VALUE ENGINEERING STUDY

Project # IMNH0-0285-01(352) PI No. 713300-

I-285 at Bouldercrest Road Interchange
DeKalb County, Georgia

23 February 2012

PROPOSAL NUMBER: R-10.0

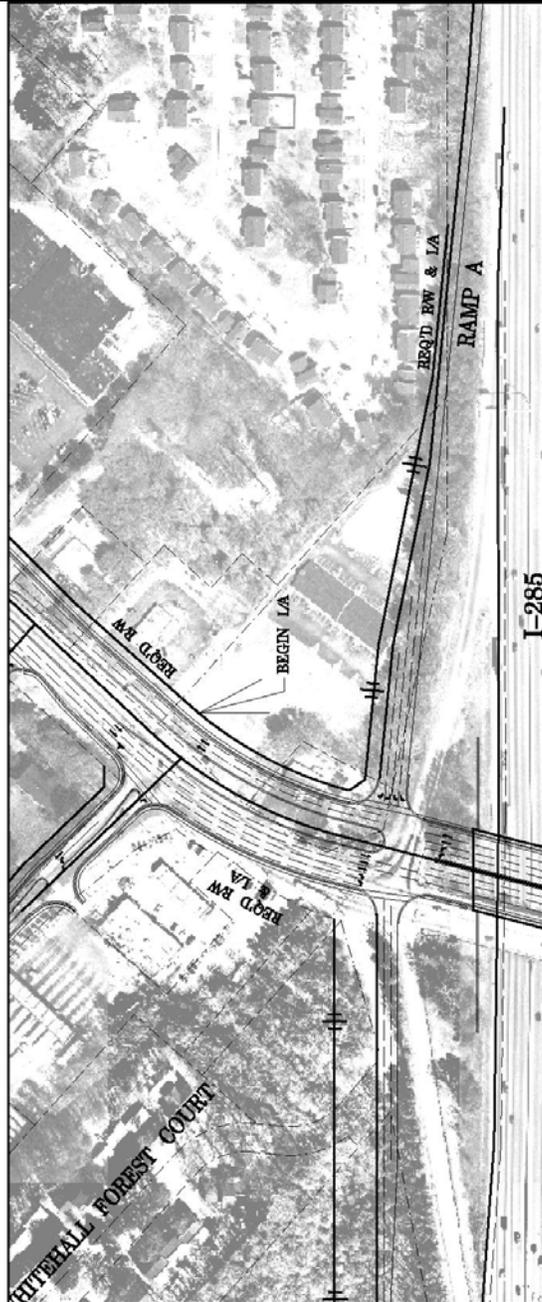
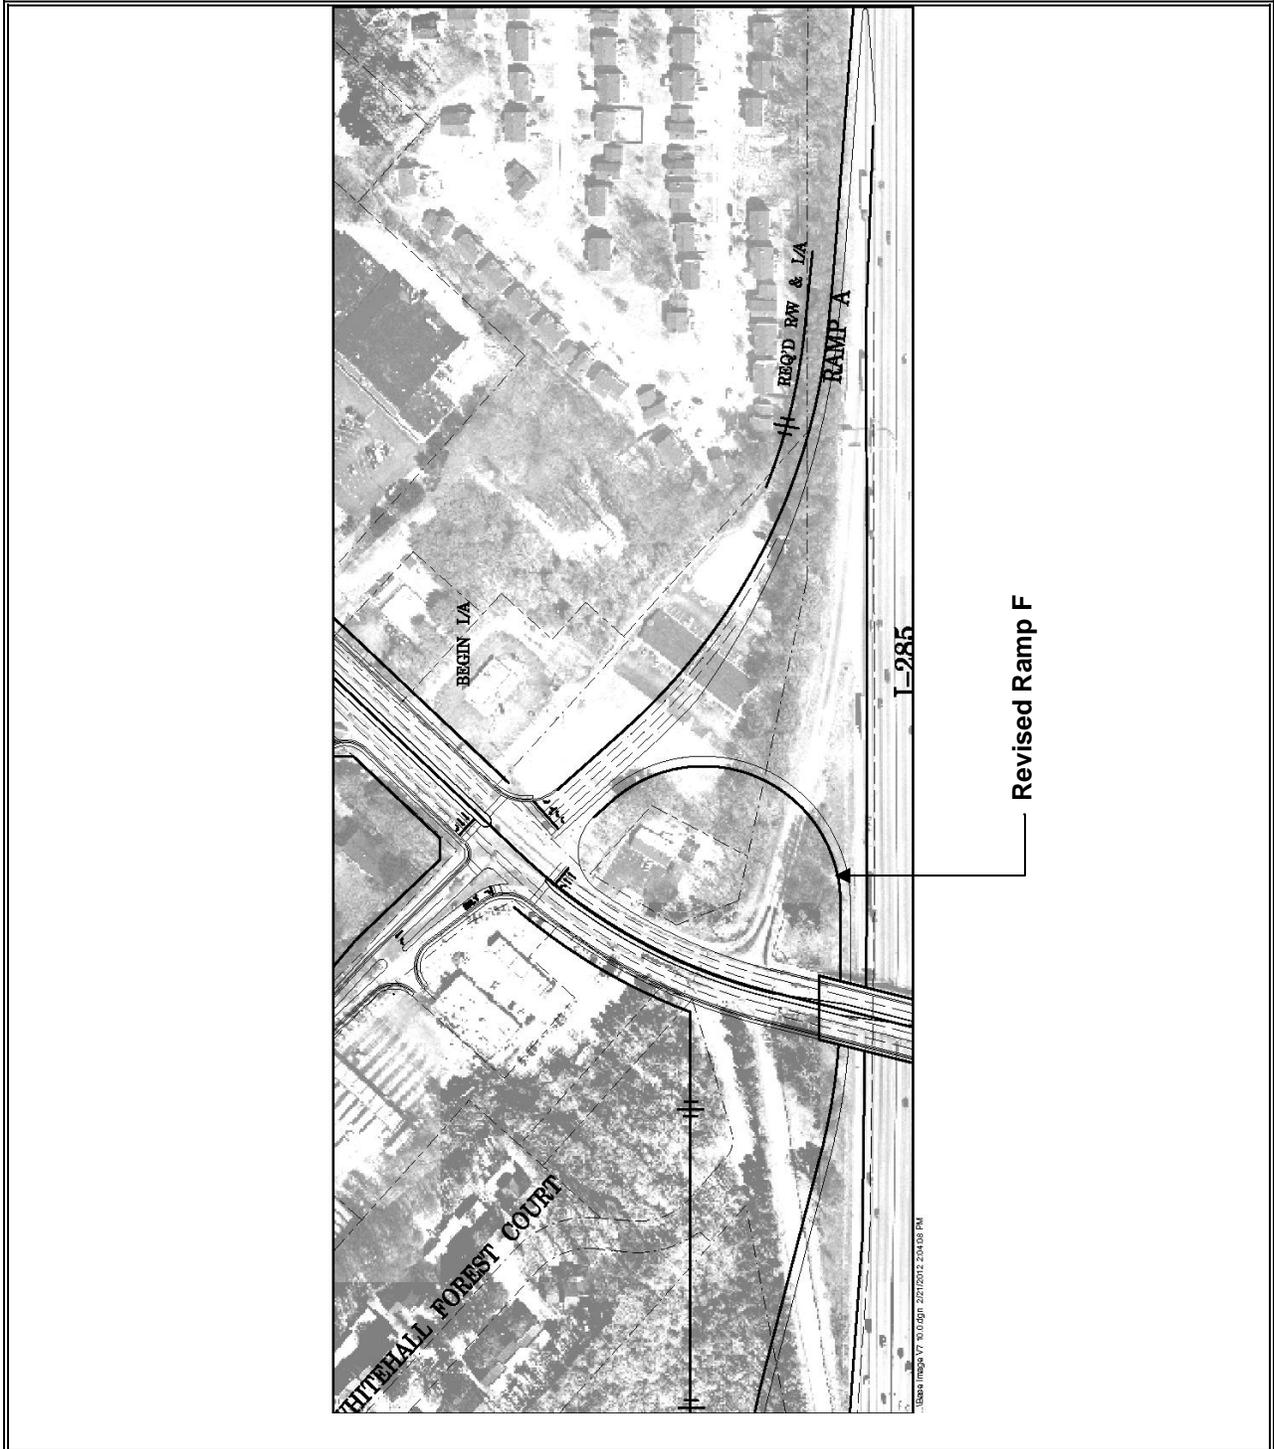
PROPOSAL DESCRIPTION: Realign Ramp “A” to intersect at Continental Way and add Loop Ramp (Ramp F revised) from Bouldercrest to I-285 WB. Reduce the number of lanes on the Bouldercrest bridge replacement over I-285 to eliminate the 2 lane left turn bay.

Because the intersection of Continental Way with Bouldercrest is within the minimum distance for a median opening to a ramp radius return (660 ft minimum required, 250 ft actual), the intersection is retained, but a raised median is added and Continental Way is made into a right-in, right-out.

The Proposed Change realigns Ramp A to intersect with Continental Way, increasing the distance of the intersection from I-285. Traffic from Ramp A is allowed through the intersection to Continental Way and allowing the intersection to maintain lefts from Bouldercrest Road NB onto Continental Way.

A Loop Ramp (Ramp F revised) allows access to I-285 WB and I-675 SB. A dedicated right turn is added for NB Bouldercrest Road.

PROPOSAL NUMBER: R-12.0

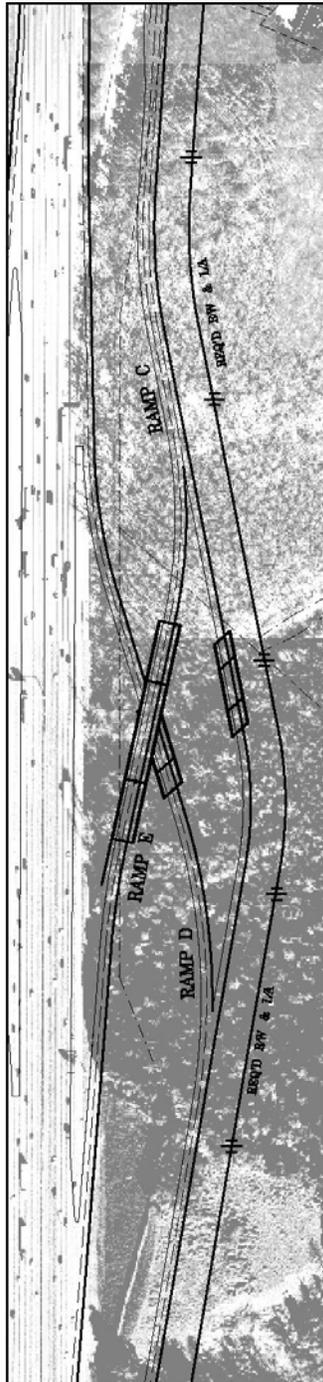
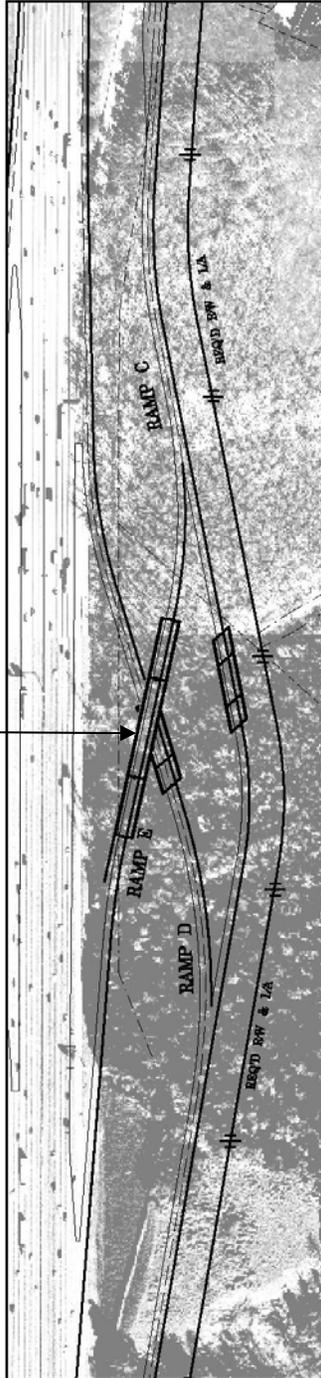
PROPOSED CHANGE: It is proposed to reduce Ramp “E” to one lane.

PROPOSAL NUMBER: R-13.0

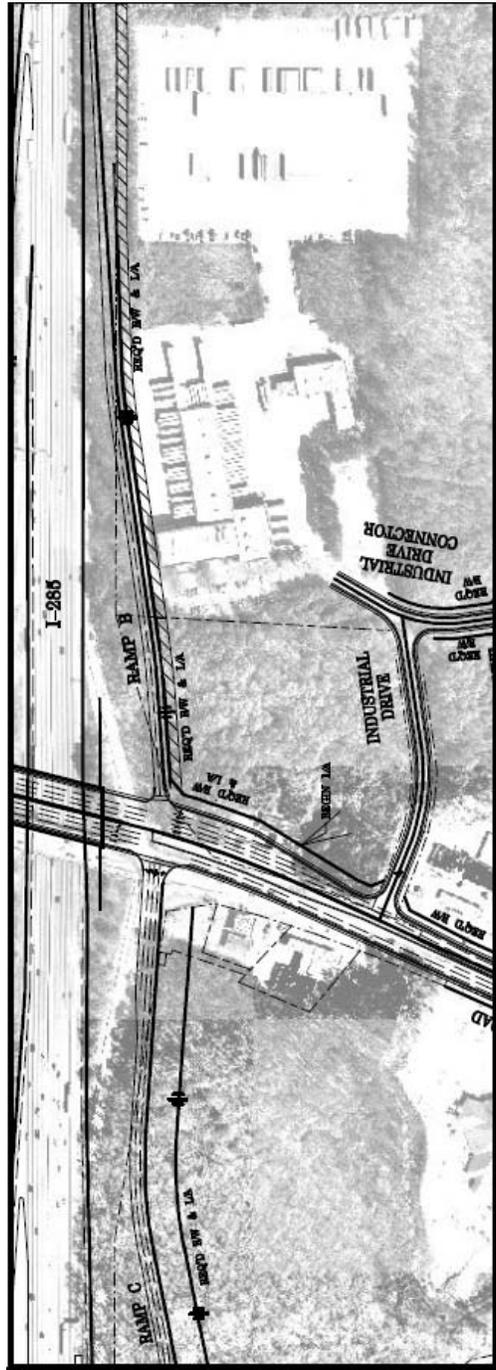
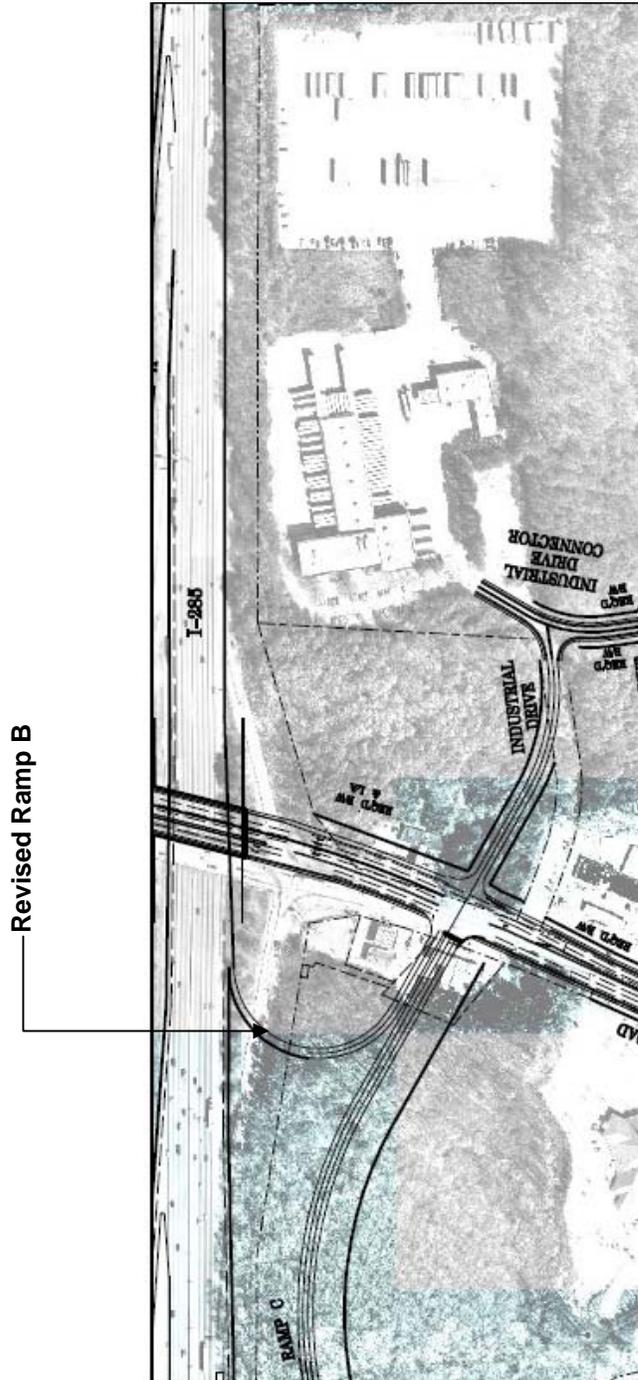
PROPOSAL DESCRIPTION: Realign Ramp “C” to intersect at Industrial Drive and add Loop Ramp (Ramp B revised) from Bouldercrest to I-285 EB, Reduce the number of lanes on the Bouldercrest bridge replacement over I-285 to eliminate the 2 lane left turn bay.

Industrial Drive is within the minimum distance for a median opening to a ramp radius return (660 ft minimum required, 400 ft actual), the intersection is retained, but a raised median is added and Industrial Drive is made into a right-in, right-out.

The proposed change realigns Ramp C to intersect with the realigned Industrial Drive, increasing the distance of the intersection from I-285. Traffic from Ramp C is allowed through the intersection to Industrial Drive and allowing the intersection to maintain lefts from Bouldercrest Road SB onto Industrial Drive.

A Loop Ramp (Ramp B revised) allows access to I-285. A dedicated right turn is added for SB Bouldercrest Road to Ramp B-revised. Removes 1600 LF retaining wall from current Ramp B design.

PROPOSAL NUMBER: R-15.0

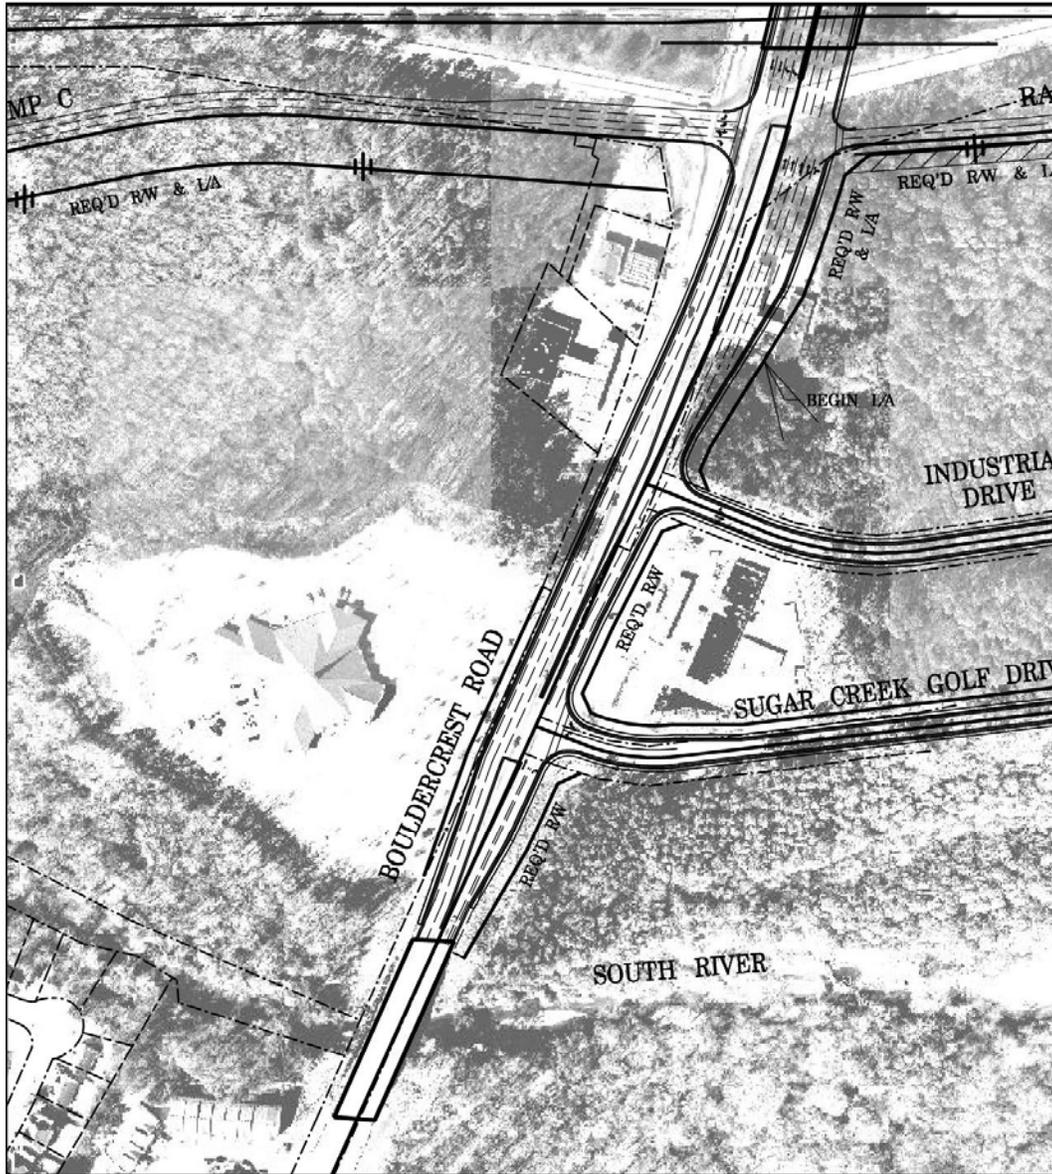
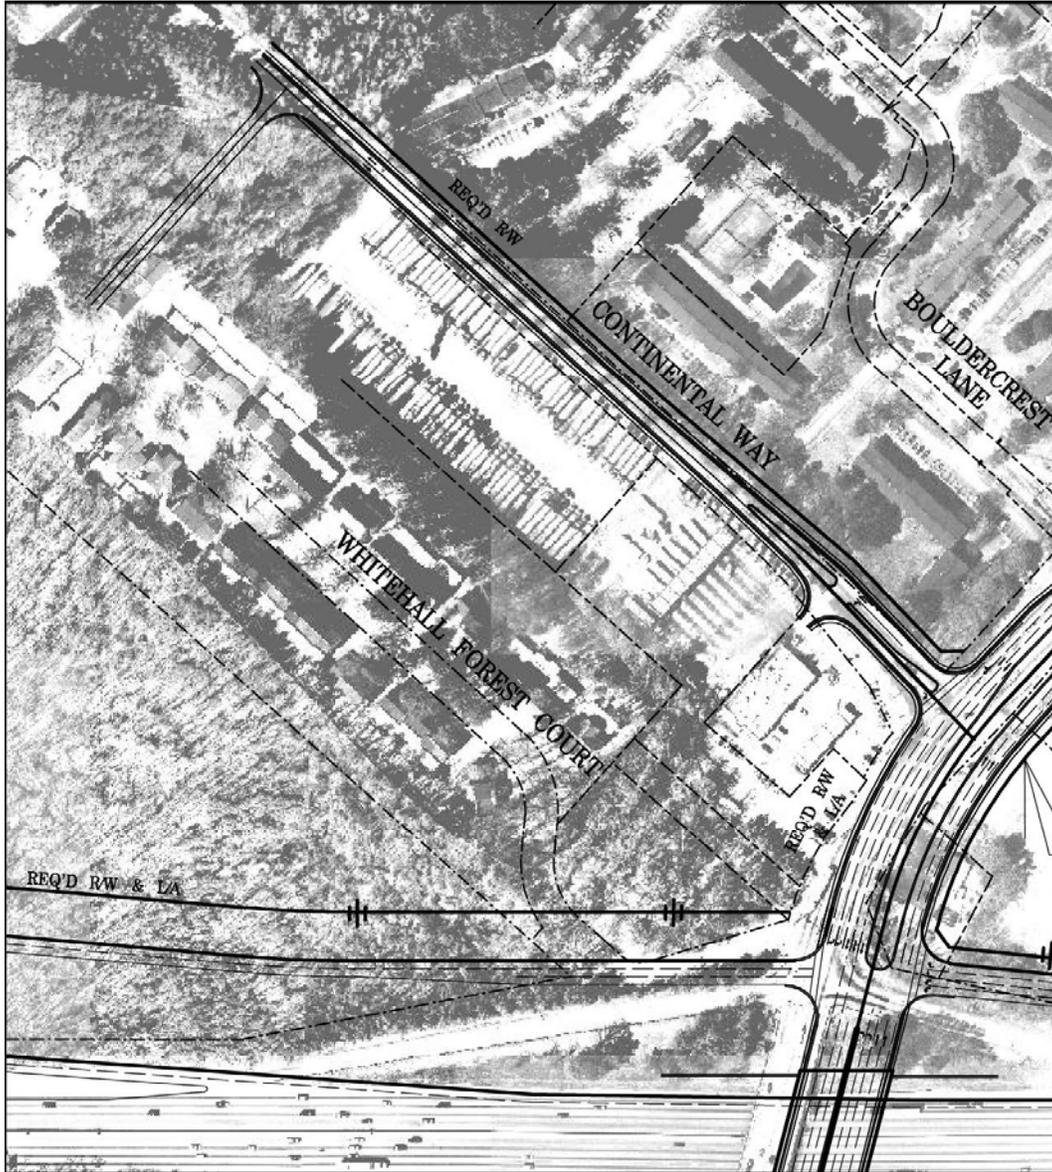
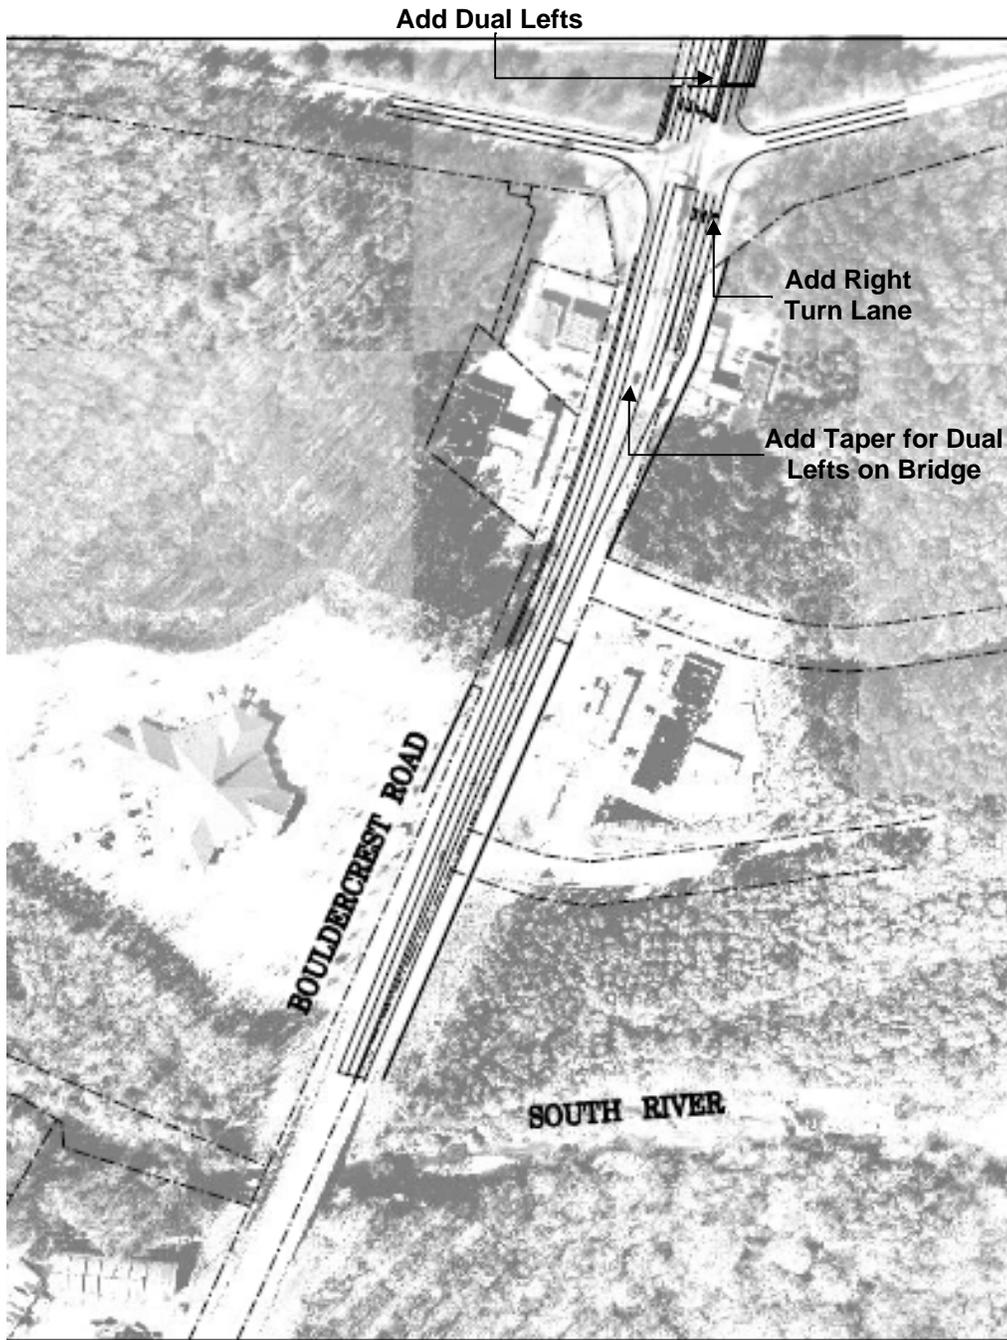
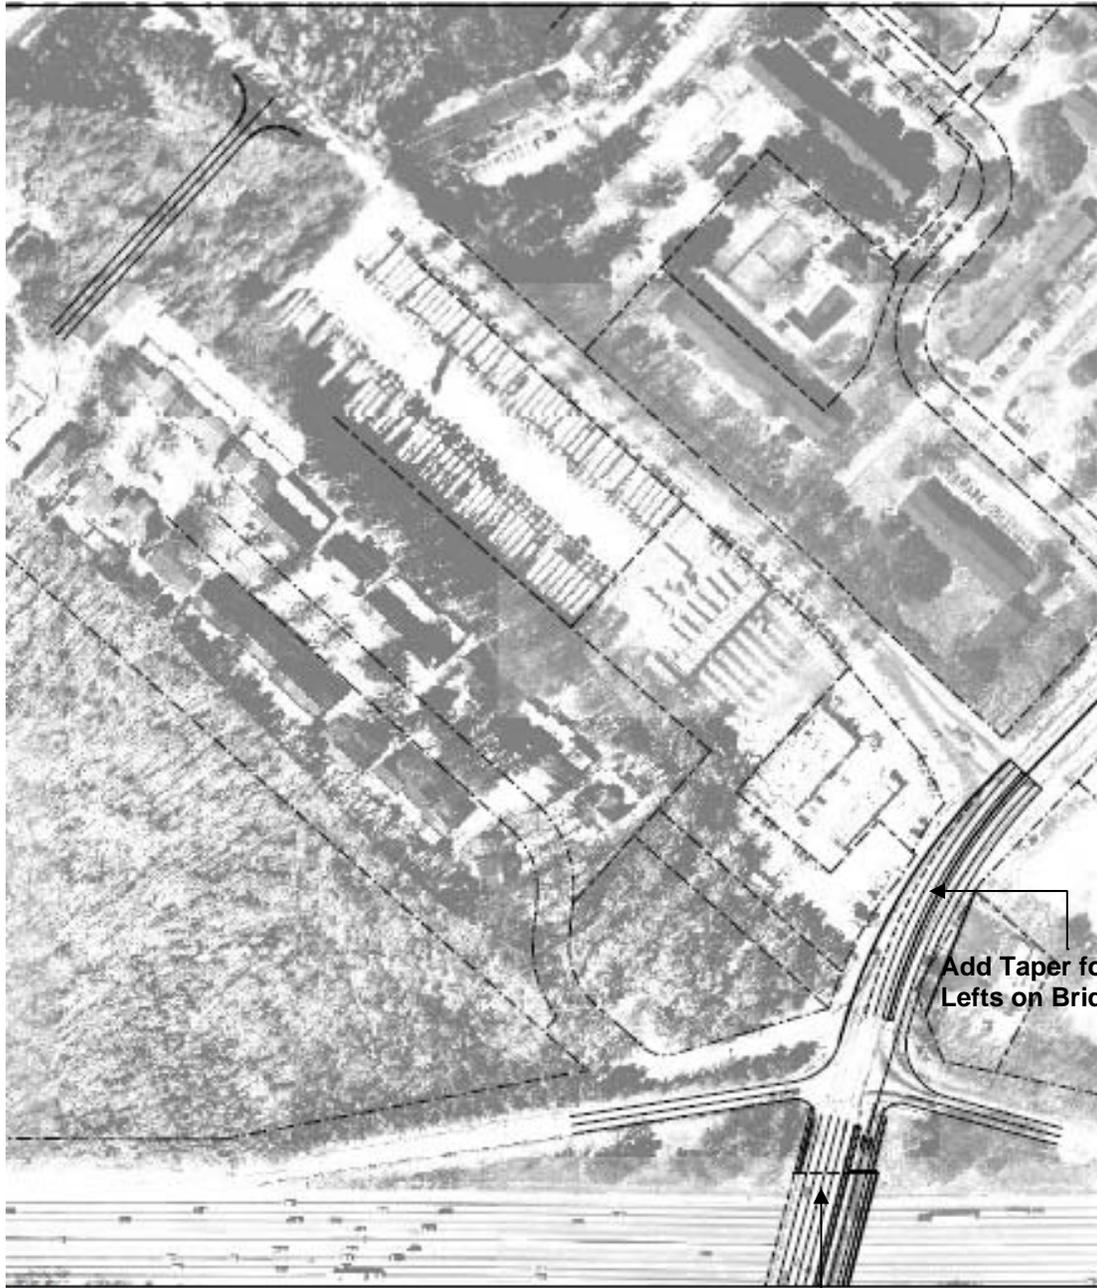
ORIGINAL DESIGN: The original design provides separate, isolated ramps in order to reduce weaving of exiting traffic from three systems affected: I-285, I-675, and Bouldercrest Road. This configuration uses multiple bridges to isolate ramp movements and braid traffic in an effort to improve operations along I-285 between I-675 and Bouldercrest Road. Bouldercrest Road also undergoes total reconstruction to provide truck traffic circulation due to ramp modifications and R/W provisions.

PROPOSED CHANGE: It is proposed to limit the scope to focus on only those improvements necessary to improve operations on Bouldercrest Road. A traffic study showed that the only movements along Bouldercrest needing improvement are those to travel onto I-285 Eastbound. Thus, a revised scope will include widening of the existing Bouldercrest bridge over I-285 with a structure providing dual left turns in the Southbound direction and adequate capacity for through traffic growth. Also, construction of a Whitehall Forest Connector will be required off of Continental Way.

JUSTIFICATION: The proposed change improves the operations at the intersection of the I-285 EB entrance and exit ramps at Bouldercrest Road. This reduced scope eliminates work along Bouldercrest Road that is not necessary based on latest traffic study.
